Docket Item # 7
BAR CASE #2008-0137

BAR Meeting
December 17, 2008

ISSUE: Alterations and Signage
APPLICANT: Jeffrey Taylor for Trader Joe's
LOCATION: 612 North St. Asaph Street
ZONE: CRMU-X/Mixed Use Commercial

Figure 10: Original proposed floor plan from July 2008 showing windows (circled) proposed to be blocked for storage space

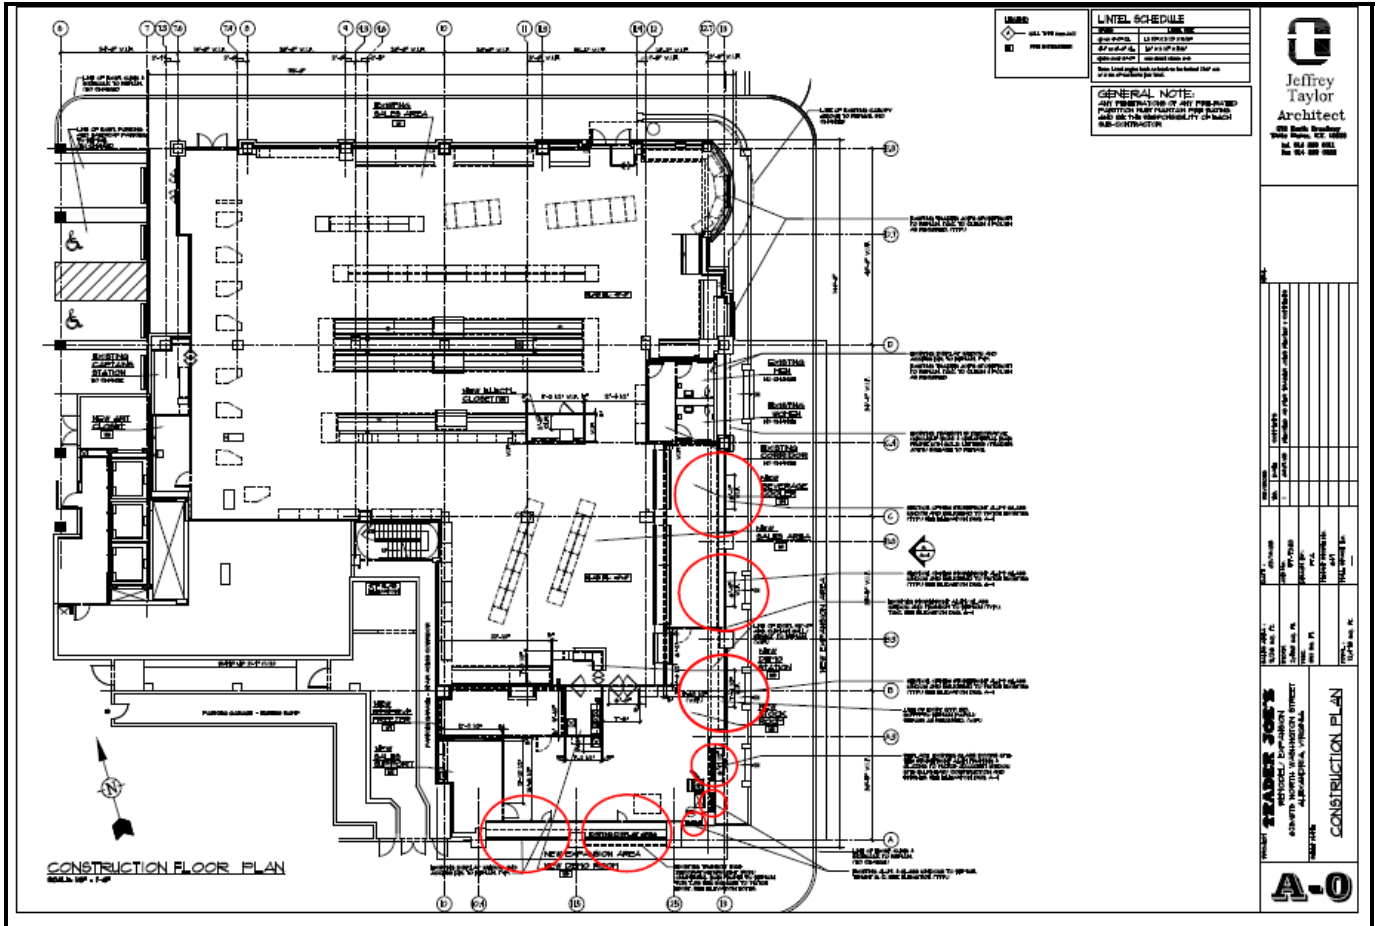
Trader Joe's originally submitted an application for the door alterations and signage in July 2008. In addition to the original application being incomplete, Staff had a number of concerns related to the proposal, in part, because Trader Joe's is located within a building approved under a Development Special Use permit. When it was originally approved in 1998, both BAR and Development Staff were particularly interested in making the commercial/retail building be accessible and pedestrian friendly. When the current application was submitted in July, Staff's major concern related to the fact that the grocery store was internally focused, with all of the windows along Pendleton Street and St. Asaph Street – over 139' of frontage along St. Asaph Street and 59' along Pendleton Street – proposed to be obscured. Since July, Staff has had a number of productive meetings with the applicant, and Trader Joe's has completely revised the interior layout to address Staff's concerns and desire to have an open and transparent street frontage. At the recommendation of Staff, the applicant now proposes to install open shelving at the perimeter of the store with products that will be visible from the sidewalk (not unlike the attached photo of a Harris Teeter grocery store). In the opinion of Staff, the expanded grocery store will be an asset to the neighborhood, both aesthetically and functionally.

Because the applicant worked so closely with Staff over the past few months, there is only one outstanding issue that pertains to Staff's desire to have an additional sign installed at the corner of St. Asaph Street and Pendleton Street. Because the existing door at the corner will become a second entrance (the existing entrance door along the drive aisle will be permanently locked), Staff believes that it would be beneficial to see a sign in this location to help animate this corner of the building. While Staff would prefer to have the sign visible from Washington Street – it could be a blade sign or a larger awning at the corner with signage on the valance – a less visible option may be the addition of a Trader Joe's sign in the same gold lettering over the Pendleton Street/North St. Asaph Street door. The applicant has expressed a willingness to install an additional sign in this location; however, the building owner must approve any additional signage beyond what is currently proposed by Trader Joe's. Staff will continue to work with the building owner and the applicant to achieve an additional sign in this location that is consistent and compatible with the existing signage.

Figure 11: Proposed Floor Plan

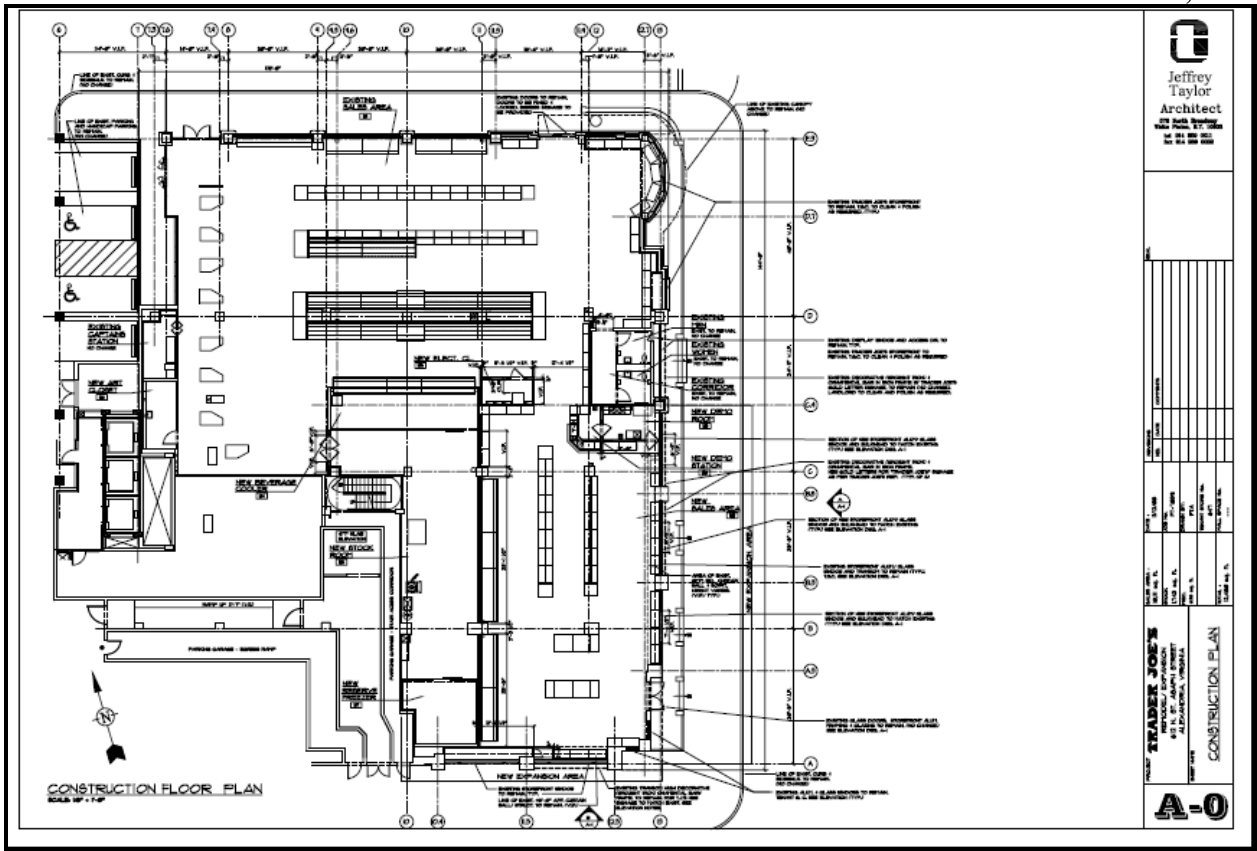
One mutually agreed upon change which was inadvertently left off of the drawings is the removal of the murals and blinds on the windows at the corner of St. Asaph Street and the drive aisle. These windows will also have the open shelving visible from the right-of-way.

1. That the applicant work with Staff and the building owner to achieve an additional sign for Staff approval at the store corner of Pendleton Street and St. Asaph Street; and,
2. That the murals and blinds currently obstructing the windows at the corner of St. Asaph Street and the drive aisle into the parking garage be removed so that the interior of the store is visible from the right-of-way.
